IV. REMARKS

Applicant is appreciative of the Examiner's finding of allowable subject matter as stated on page 6 of the Office Action mailed June 11, 2004. Claims 16 and 19 have been rewritten in independent form including all of the limitations of the base claim and any intervening claims and are now new claims 21 and 22 herein.

FIG. 1

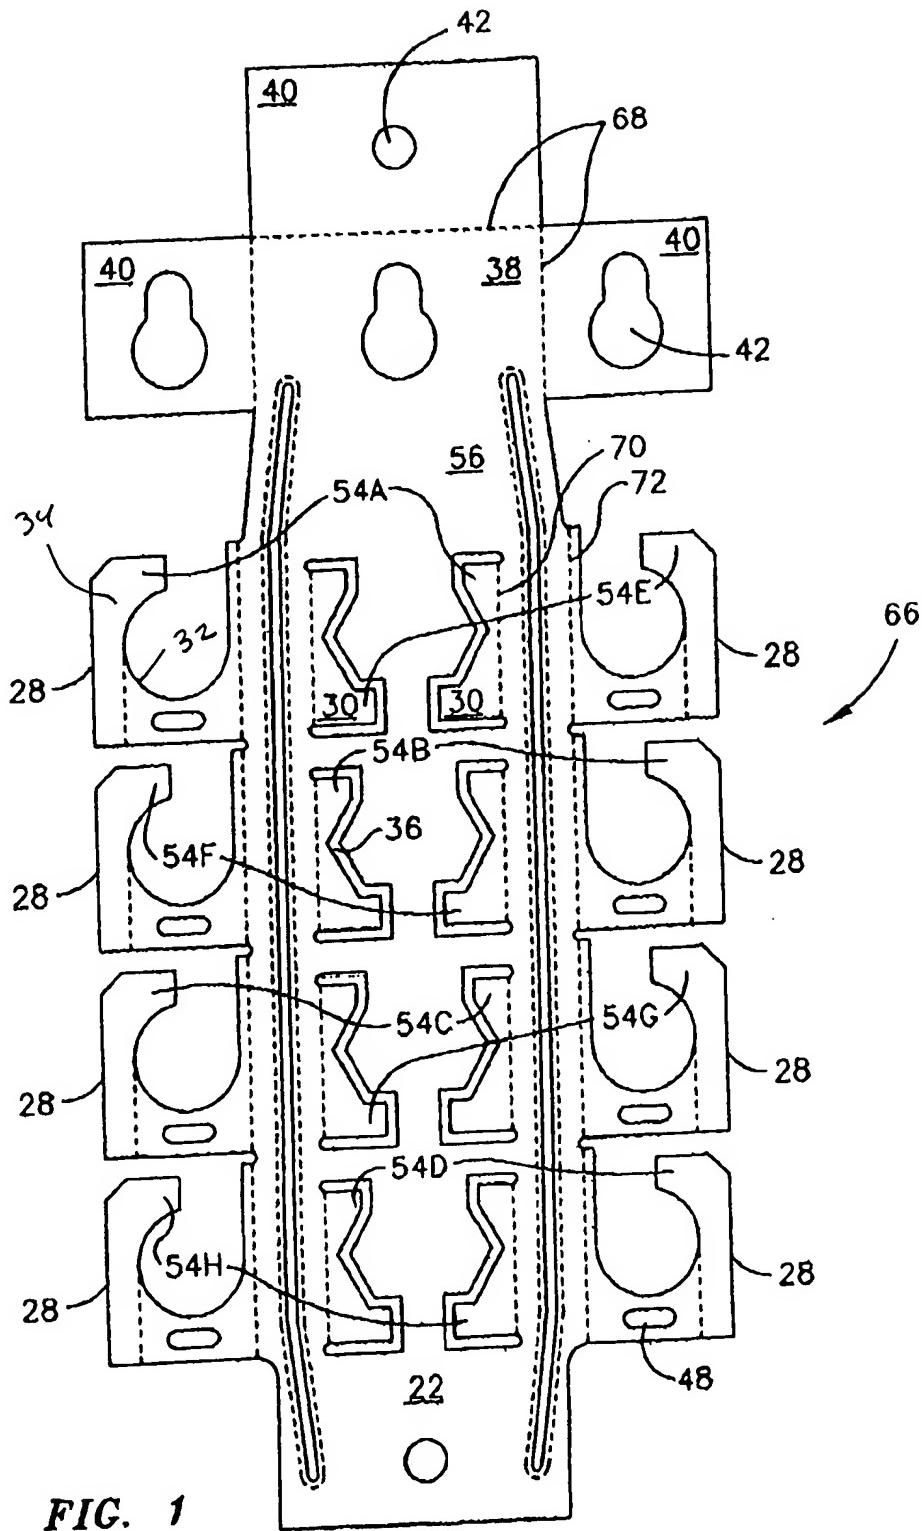
The Examiner states on page 4 of the Office Action that the three ears extending from each side of the head in claim 4 must be shown or the features canceled from the claims.

Applicant has herein submitted replacement sheets for Fig. 1 (sheet 1 of drawings), Figs. 2 and 3 (sheet 2), Figs. 4 and 5 (sheet 3) and Fig. 6 (sheet 4). To understand the relationship of the three ears extending from each side of the head, the Examiner is referred to Fig. 6, which shows three ears 40 extending from the head 38. It is stated in the present application that "the bend lines are shown in broken lines on Fig. 1 and include the bend lines 68 for forming the head 38" (page 9, lines 3-4). Therefore, as shown in Figs. 1 and 6, there are three ears 40 and they extend from each side of the head 38 with the head 30 being the top portion of the base 22 (see Fig. 1) and the sides of the head 38 denoted by the bend lines 68 (see Fig. 1).

Regarding the Examiner's comments regarding claim 4 on page 4, Applicant refers the Examiner to the previous paragraph which clarifies the number of heads 38 by reference to replacement Figs. 1 and 6.

FIG. 6

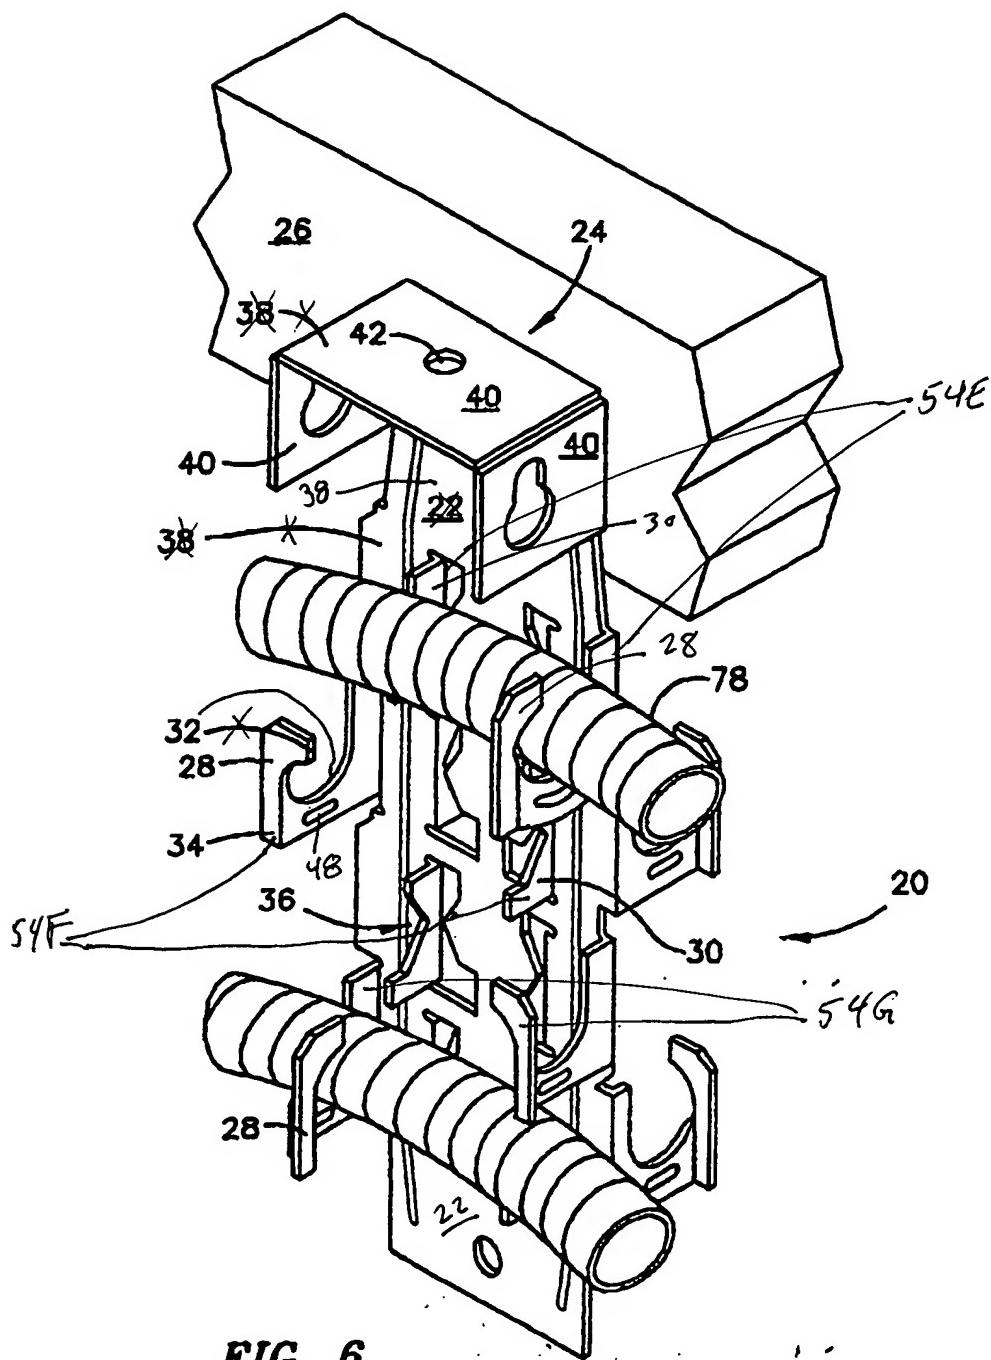
The Examiner further states on pages 4 and 5 that: it is unclear whether the word "on" in the above phrases means that the first holding member is made up of the arcuate cable holding member and the deformable member or whether the first holding member is a separate element. The Examiner further states that it is unclear where the arcuate cable holder begins and the deformable member ends.

Applicant refers the Examiner to the plan view of a blank that will be formed into a cable holder in Fig. 1 and the perspective view of the cable holder in Fig. 6 for a clarification on the details of the first holding member 28. As stated in the application "the first holding member 28 typically extends at a 90 degree angle from the base 22 and includes a deformable member 34 extending at an angle of 90 degrees from the first holding member 28. The arcuate cable holder 32 is an open area in the first holding member 28 that includes between 260 and 280 degrees of arc of a full circle. The deformable member 34 extends from the first holding member 28 at a point between 155 and 165 degrees of said arc away from the base 22" (page 7, lines 9-14). As shown in Fig. 1, the arcuate cable holder 32 extends between 260 and 280 degrees of arc around the inner periphery of the first holding member 28. The deformable member 34 extends from the first holding member 28 at between 155 and 165 degrees of the arc. The arc of the arcuate cable holder 32 begins at the portion of the inner periphery of the first cable holder 28 along the side adjacent the base 22 and extends therefrom to the opposite end. After the blank has been bent along the bend lines (shown in dashed lines in Fig. 1) to form the first cable holder 28 at a 90 degree angle to the base 22 and the deformable member 34 at a 90 degree angle to the remainder of the first holding member 28 as shown in fig. 6, the arcuate cable holder 32 includes a total arc of between 260 and 280

degrees of arc of which 155 to 165 degrees of arc are in a plane perpendicular to the base 22 and the remainder of the arc are in a plane parallel to the base 22. As further stated in the application “a screwdriver or similar leverage tool (not shown) is then inserted into the slot 48 in the first holding member 28. Pressure is then exerted on the first holding member 28 until the deformable member 34 secures the cable 78 against the base 22. Exerting pressure on the slot 48 causes the first holding member 28 to buckle or bend in the vicinity of the slot 48 and thereby collapse the channel 46. The deformable member 34, being integral with the base 22 and constructed of steel, deforms against the cable 78 and secures it against the base 22. The screwdriver is then removed from the slot 48 and the deformable member 34 retains its deformed shape, thereby trapping the cable 78 against the base 22” (page 9, lines 12-20). The arcuate cable holder 32 therefore includes the entire arcuate inner periphery of the first cable holder 28 and the deformable member 34 includes the outer portion of the first cable holder 28 beginning at 155 to 165 degrees of arc from the start of the arcuate cable holder 28 adjacent the base 22.
